## Addendum

ADDENDUM NO.: 2 DATE: 4/5/2021

PROJECT TITLE: Fretwell Café Renovations  
University of North Carolina Charlotte  
SCO ID# 19-21437-01A  
WTS Project No. 2007

**1**  
A7.02  
1/4" = 1'-0"

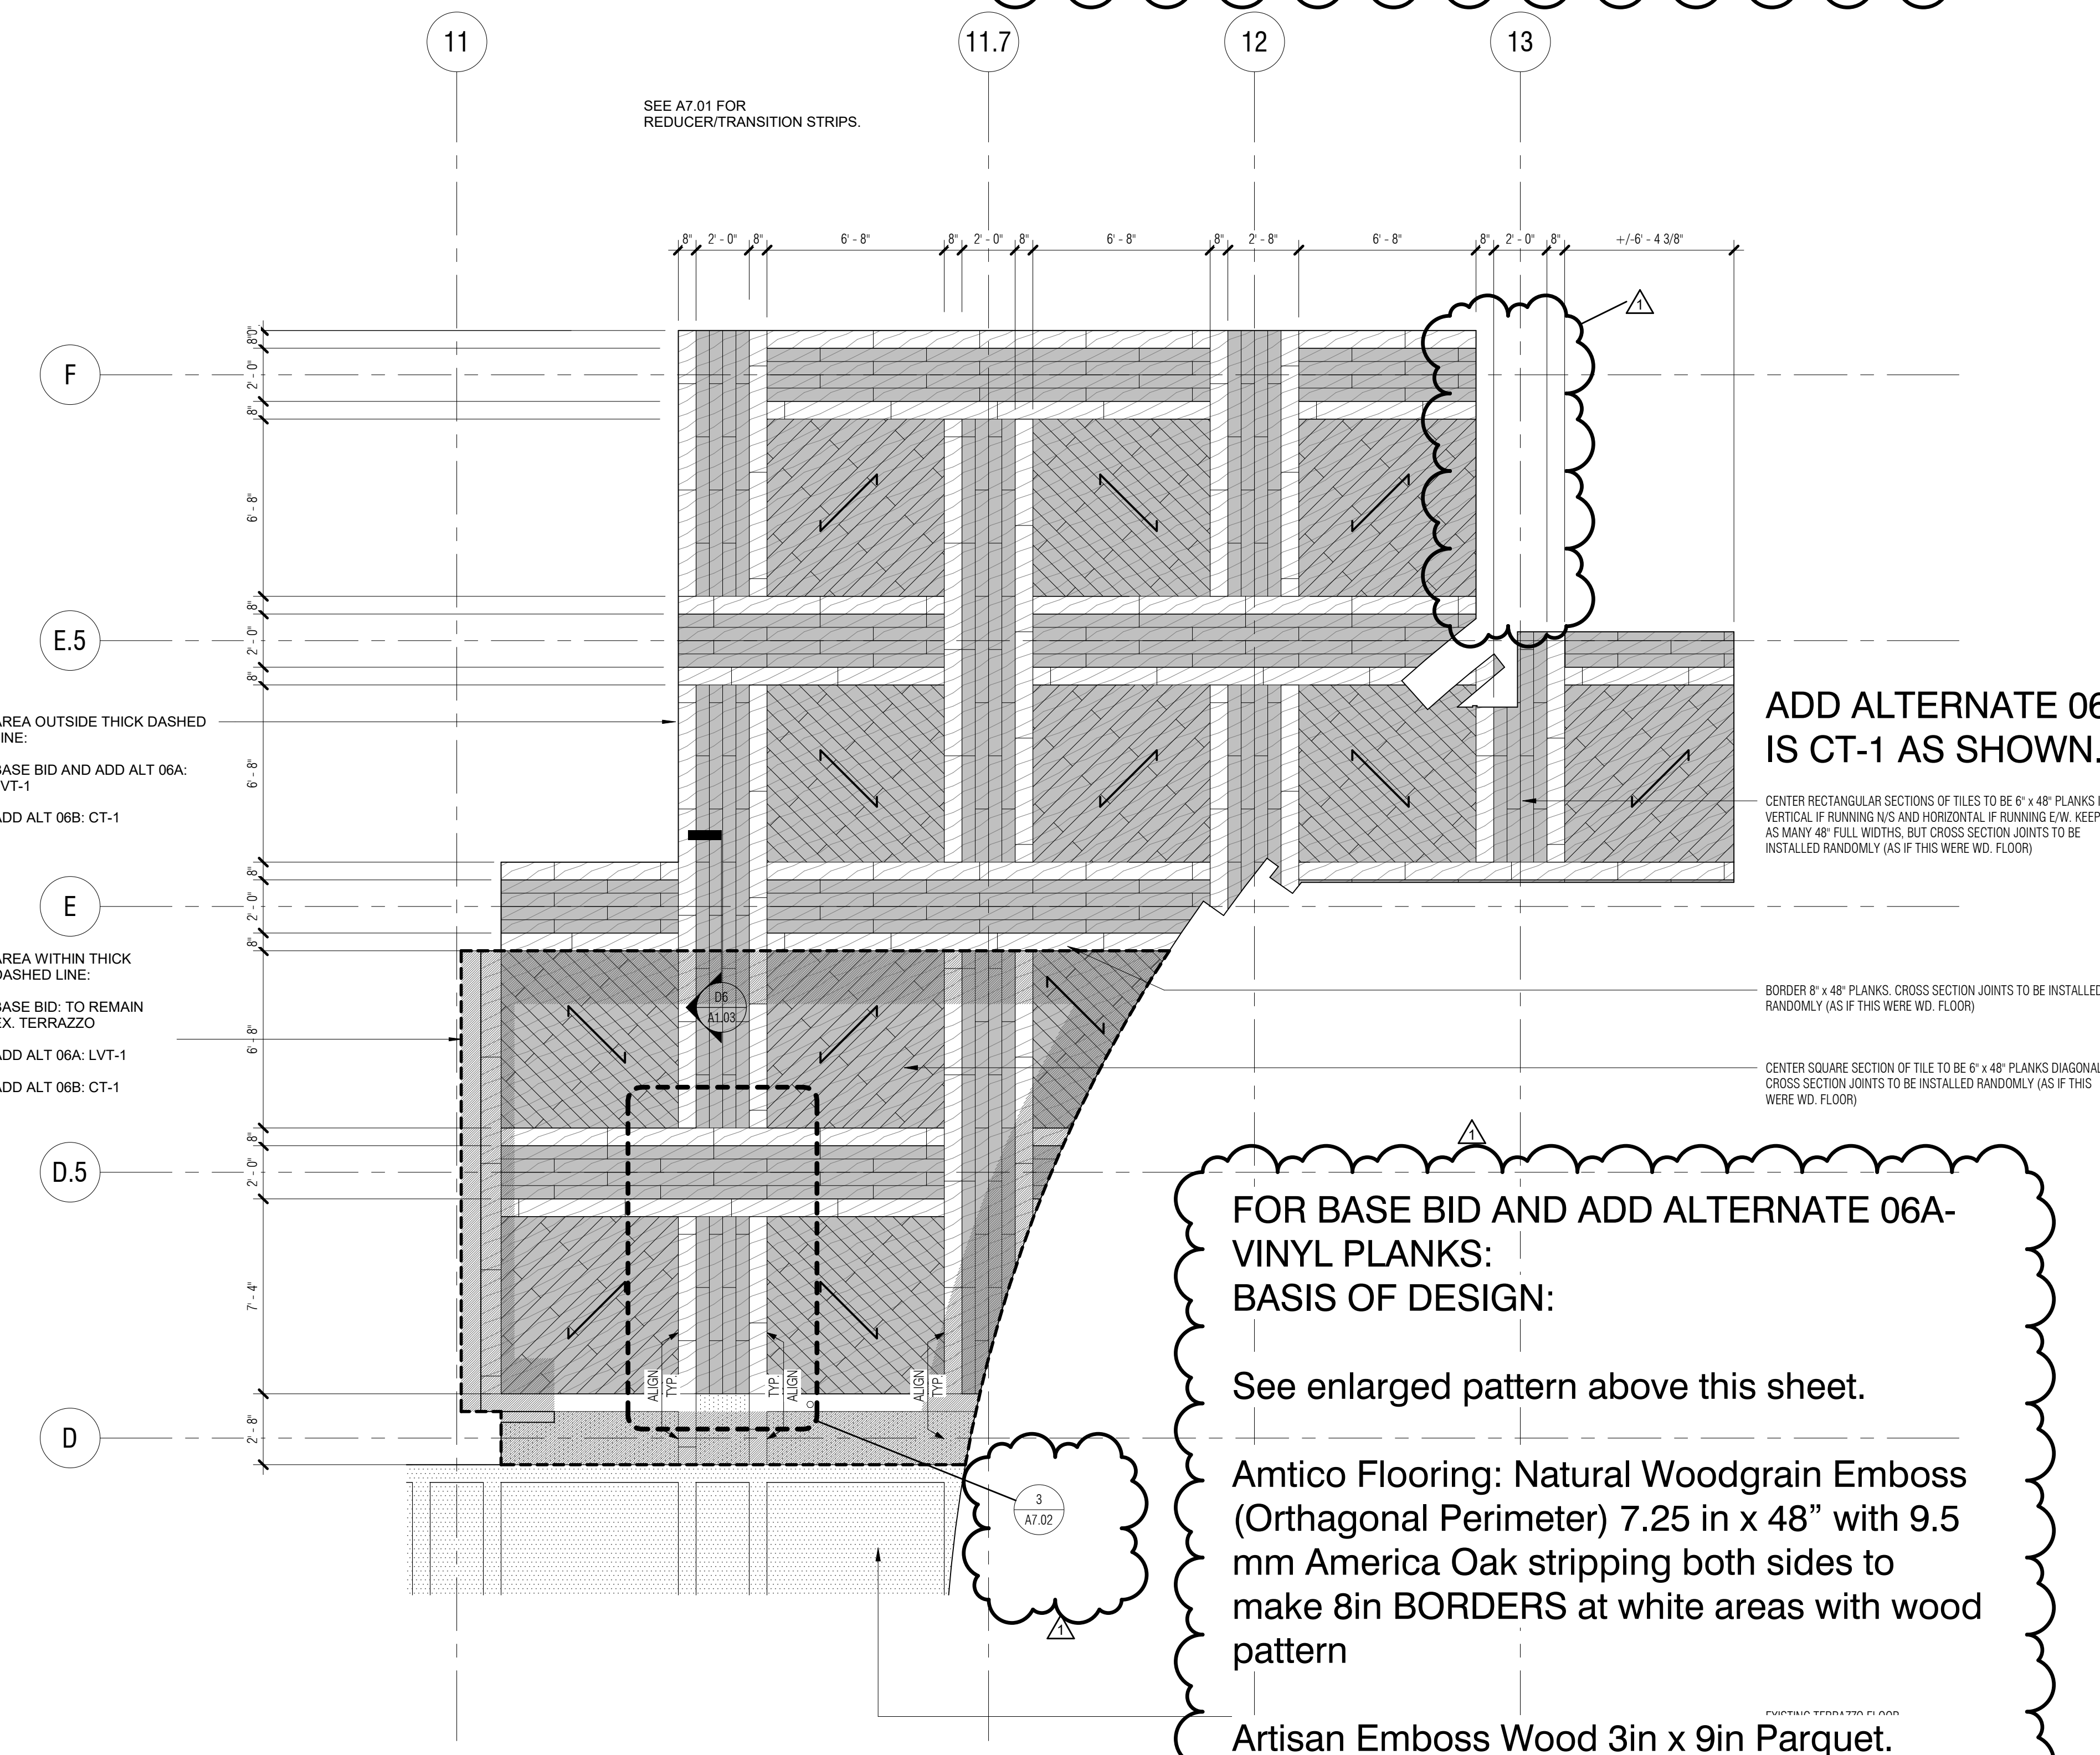
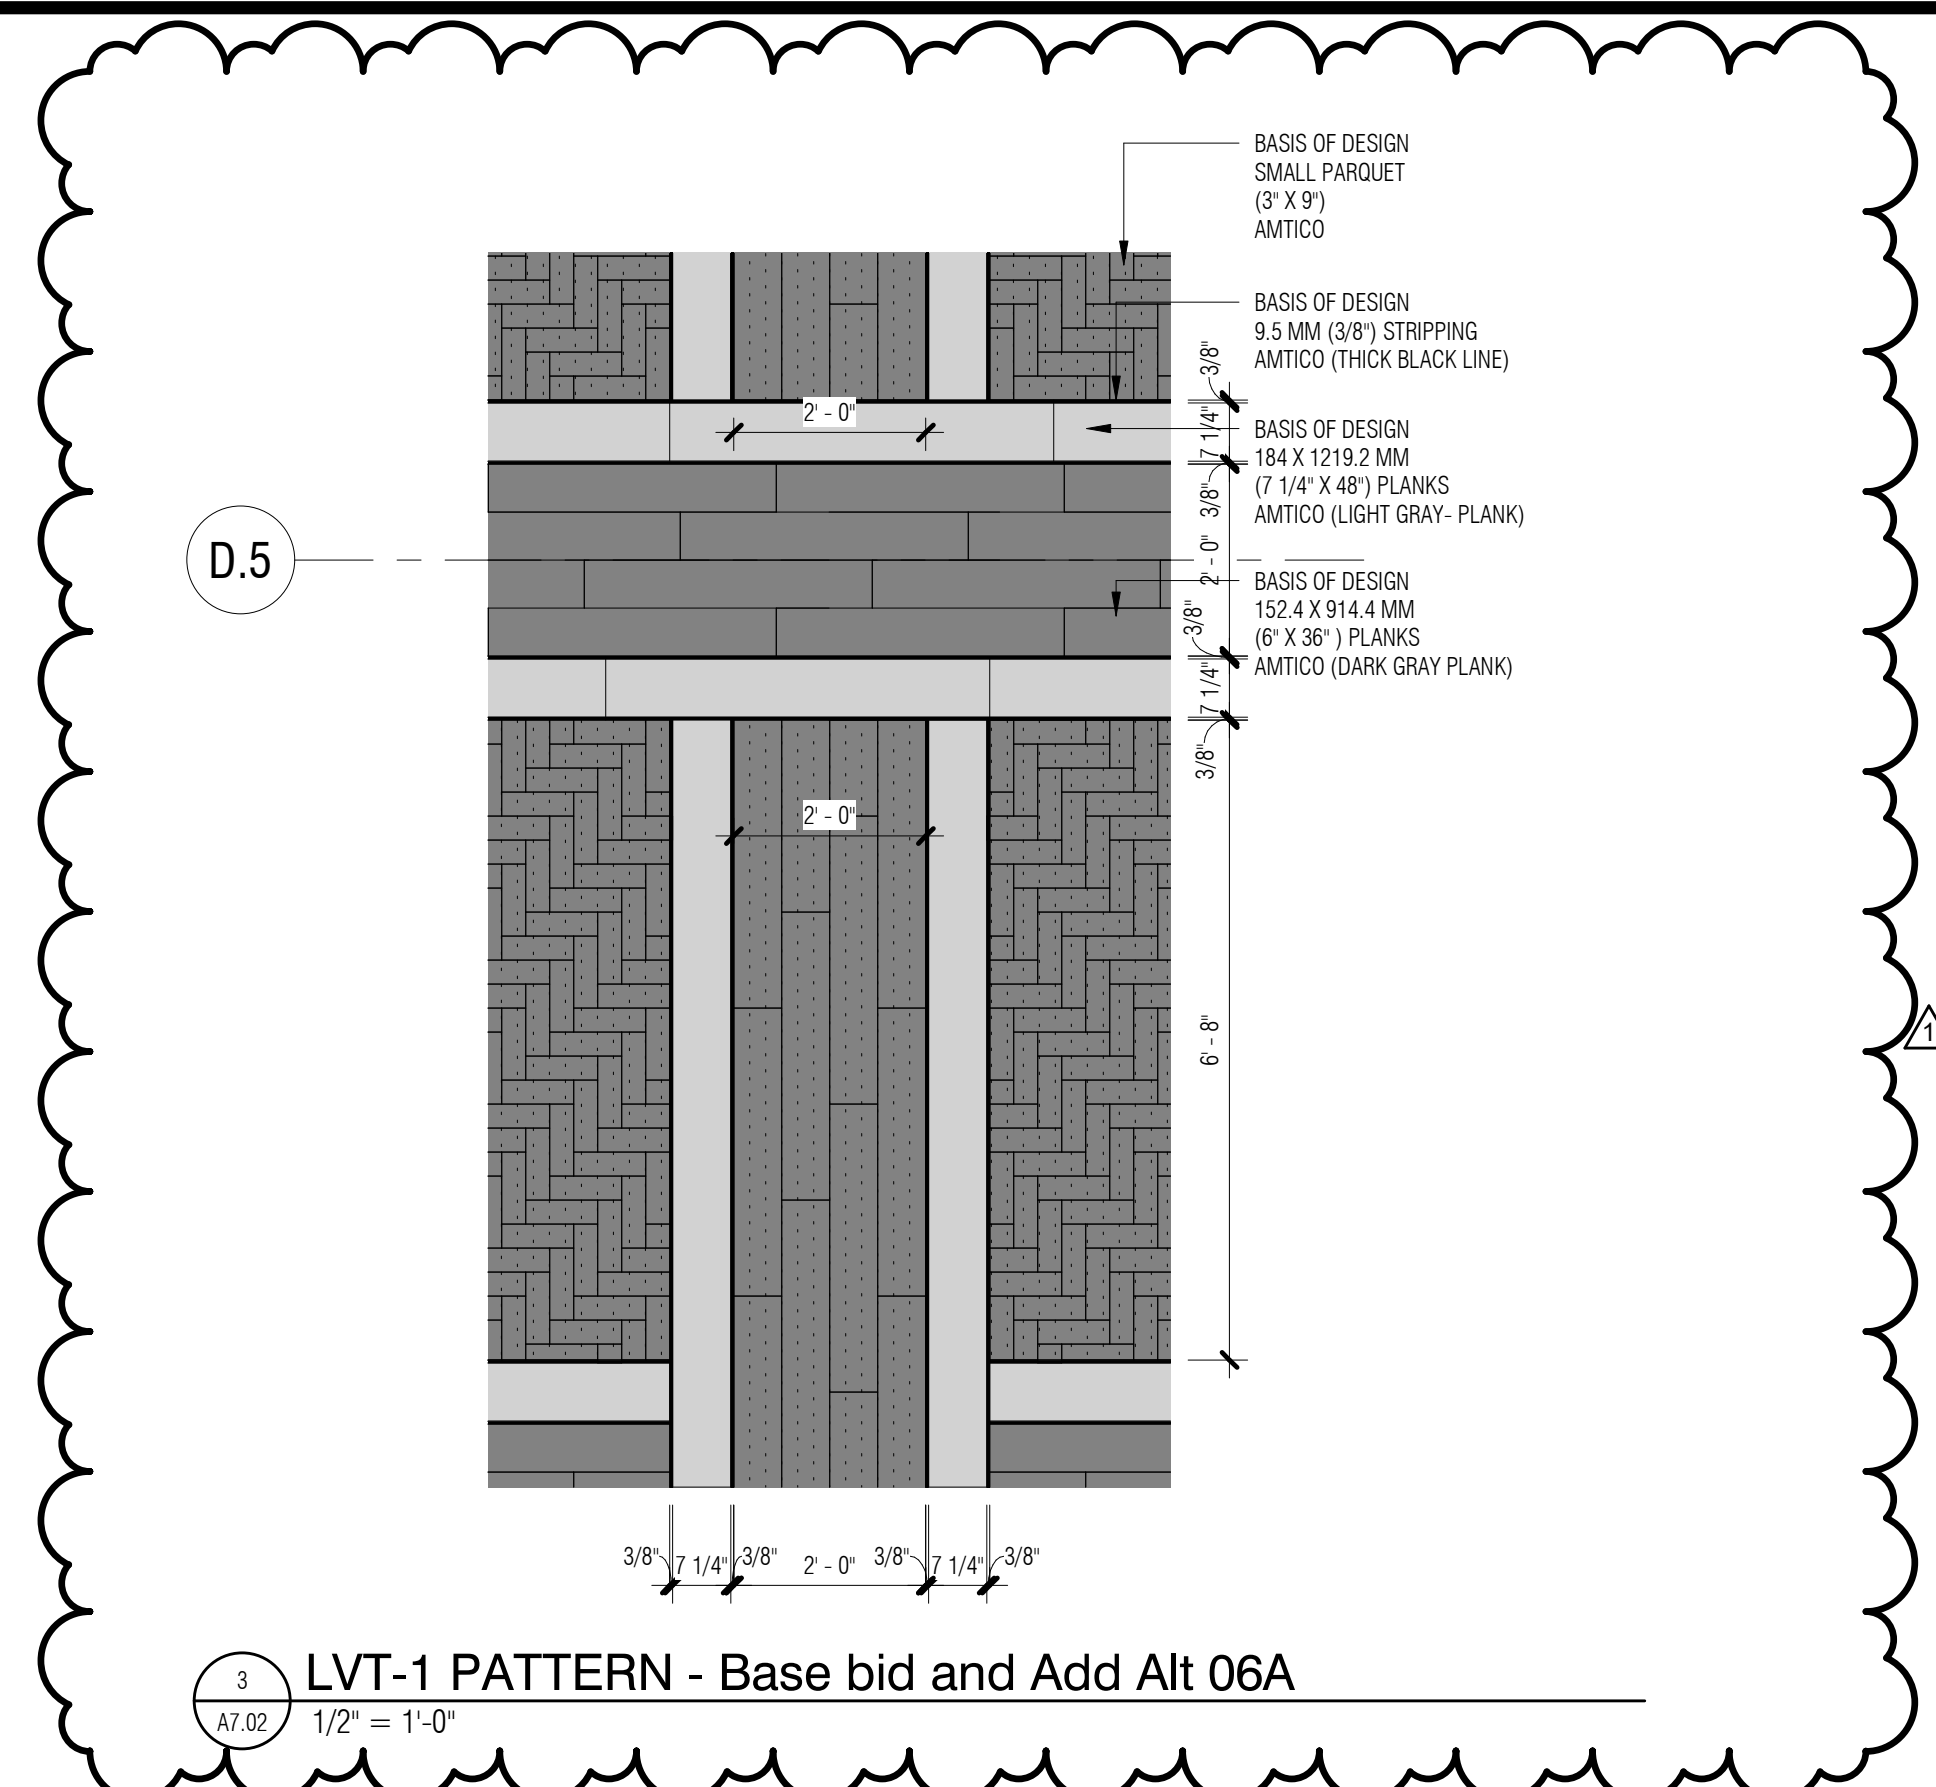
1. Revise 09 6519 RESILIENT TILE FLOORING 2.1 A; 1. Amtico Flooring: Natural Woodgrain Emboss (Orthogonal Perimeter) 7.25 in x 48" with 9.5 mm America Oak stripping both sides to make 8in; 6 in x 36 in planks between 8 in. bands and Artisan Emboss Wood 3in x 9in Parquet as indicated on Sheet A7.02.
2. Add the following to 2.5 Acoustic Panel APC-3 A:
  4. J2 PET Felt Acoustic Drop in Baffle Tile;
  5. Soundcore Grid Blades;
  6. Frasch! Linyfelt – Scott Miller Associates

RFI#	RFI	RESPONSE
1	The spec book calls for the base bid to be LVT for Open Seating 109 areas B & C. The finish plan on A7.01 shows existing terrazzo, CFT1 and CFT2. What should it be?	The Project Manual’s description of Add Alternates is Correct. The A7.01 sheet issued with the bid documents has been updated to match. Base Bid is a combination of existing terrazzo with LVT. Add Alt 6a is LVT and Add Alt 6b is Porcelain tile.
2	The alternate descriptions for alternates 06A and 06B on Floor Area A on the finish plan show LVT pattern as shown. The alternates described in the spec book call for LVT for alternate 06A and CT-1 for alternate 06B. Which should it be?	The description of Add Alt 06B has been revised to CT-1.
3	Should the America Oak stripping for both sides of LVT-1 be used in all instances where it is used?	The intent of the stripping is to allow the band widths to equal 8 inches wide and align with the grid pattern of the existing terrazzo in both directions. So it should be used on 8” bands both sides 3/8” + 7 ¼” + 3/8” to align with 8” bands. Infill to be the small parquet. See Reissued Sheet A7.02 for further clarification.

4	On the finish schedule under the LVT-1 listing there is mentioned of a parquet “Infill”. Where is that applied?	In base bid and Add Alternate 06A, the parquet LVT is used in between the 8” strips. See Re-issued Sheet A7.02 For Further Clarification.
5	Regarding the finish key for CPT-1, are 1.1, 1.2 and 1.3 colors Nebula, Ultraviolet and Carbon Tile respectively?	This is correct.
6	Detail 1/A7.02 on the northeast corner when imported into the finish plan looks like it extends into the vestibule 109D. Is that correct?	The Vestibule is Walk-off Carpet. Detail 1/A/7.02 incorrectly shows LVT/CT going passed the door into the vestibule. It is correct on 1/A7.01, and will be corrected on 1/A7.02.
7	At column E on the finish plan there is a note referencing A3/A8.02 calling out a floor pattern. There is no floor pattern on that page. Should that be on 1/A7.02?	This Note should reference 1/A7.02, not A3/A8.02. Sheet A7.01 will be reissued with the change to this note.
